Work Order ID 127860

Item ID: D3166-1 Accept *N900040100* Setup Start *NS1*
 Revision ID: Stop *NS2*
 Item Name: Basket Hoop
 Start Date: 1/06/15 Start Qty: 12.00 *12* Cust Item ID:
 Required Date: 1/06/15 Req'd Qty: 12.00 *12* Customer:
 Reference:

DESIGN #	DRAWN BY CP	DART AEROSPACE LTD HAWKESBURY, ONTARIO, CANADA	
CHECKED #	APPROVED #	DRAWING NO. D3166	REV. A SHEET 1 OF 1
DATE 02.07.10		TITLE BASKET HOOP	SCALE NTS
A	02.07.10	NEW ISSUE	
A1	04.04.08	38+/-1 WAS 36.0

DRAWING NO. D3166	TITLE BASKET HOOP	REV A1	DART AEROSPACE LTD ENGINEERING ORDER		D.E.O. NO. D3166-A-2	SHEET NO. 1 OF 1	SCALE NTS
DRAWN AJS	CHECKED 1	MFG. APPR. M	APPROVED MD		DE APPR. H		
DATE 08.12.11	DATE 08.12.15	DATE 08/12/15	DATE 08/12/16		DATE 08-12-16

D3166-1 BASKET HOOP

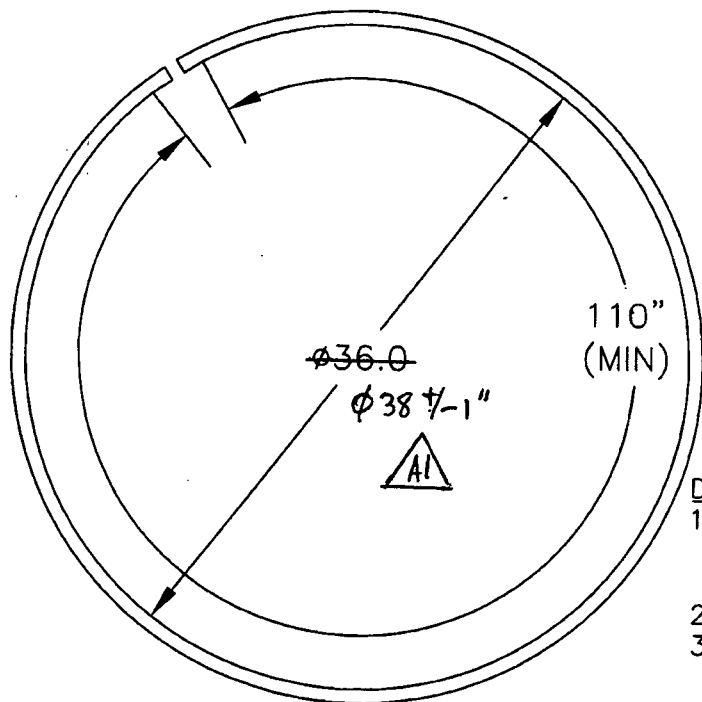
1) MODIFY MATERIAL NOTE FOR D3166-1 AS SHOWN:

IS:

WAS:

1) MATERIAL: AISI 304/316 SS SQUARE TUBING,
0.75" x 0.75" x 0.063 WALL, 60.00" LONG
(REF DART SPEC. M304TS0.750W.063)

2) MODIFY MATERIAL NOTE FOR D3166-3 AS SHOWN:

IS:

WAS:

1) MATERIAL: AISI 304/316 SS SQUARE TUBING,
0.75" x 0.75" x 0.063 WALL, 120.00" LONG
(REF DART SPEC. M304TS0.750W.063)

1) MATERIAL: AISI 304/316 SS, 3/4 X 3/4 X 0.065 WALL SQUARE TUBING,
60.00" LONG
REF. DART SPEC M304TS0.750W.065

1) MATERIAL: AISI 304/316 SS, 3/4 X 3/4 X 0.065 WALL SQUARE TUBING,
120.00" LONG
REF. DART SPEC M304TS0.750W.065
